Access Compliance Report Public Rights-of-Way (Pedestrian Signals)

Main Street: CRAWFORD_CANYON_RD Cross Street: BARRETT_LN Location: N

ADA ID: SGRK211007175056 Signal Type: One Push Button-APS Overall Compliance: No Severity Scores: BTN 1: 35 BTN 2: N/A No BTN: N/A

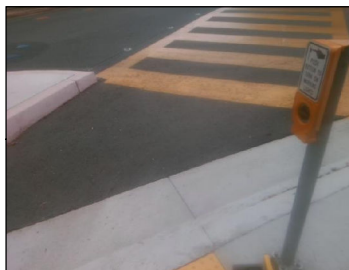
OC Std/PROW: R209.1, MUTCD 4e.08, R404.2, R404.3

Possible Solutions: Replace Signal Push Button With APS Button. Remove & Relocate Sign.
